Docket Number:	22-BSTD-01
Project Title:	2025 Energy Code Pre-Rulemaking
TN #:	252155
Document Title:	Benjamin Cohen Comments on Cooling Tower Measures
Description:	N/A
Filer:	System
Organization:	Benjamin Cohen
Submitter Role:	Public
Submission Date:	9/7/2023 7:45:27 AM
Docketed Date:	9/7/2023

BAC Comments on Cooling Tower Measures

CEC Docket 22-BSTD-01

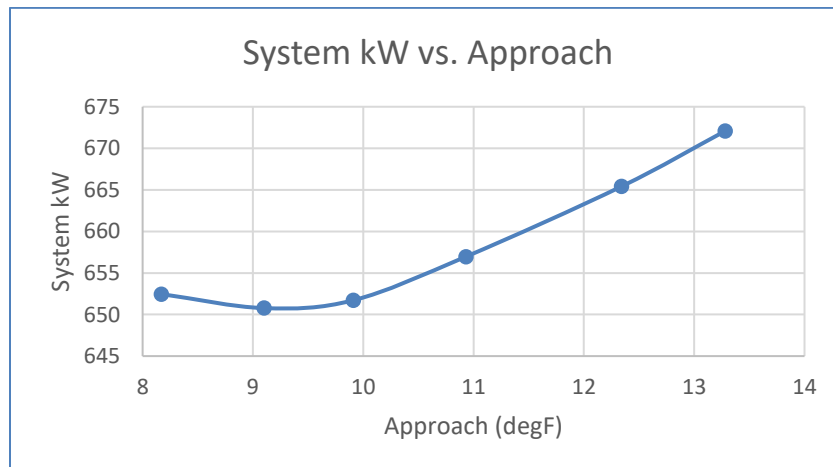
According to an experienced manufacturer's representative in CA that regularly evaluates cooling tower and chiller selections on projects to optimize overall energy efficiency at central utility plants, energy usage and costs will generally increase as GPM/HP increases. The key is to minimize system energy, not just the energy of one component, especially a component that accounts for a relatively small portion of the overall energy use.

The following chart illustrates that when a chiller plant stays within an 8°F to 10°F approach, chiller energy usage is minimized and plant efficiency is optimized. Our experience has been that an unreasonably high, prescribed GPM/HP for the cooling tower may inadvertently increase system energy. Because of this, we recommend evaluating more appropriate ways to improve total system efficiencies in future revisions, such as control sequences found in ASHRAE Guideline 36. Therefore, we respectfully suggest maintaining the current prescriptive requirements listed in Title 24 2022 (i.e., 60 GPM/HP) and delete the proposed energy rating increase.
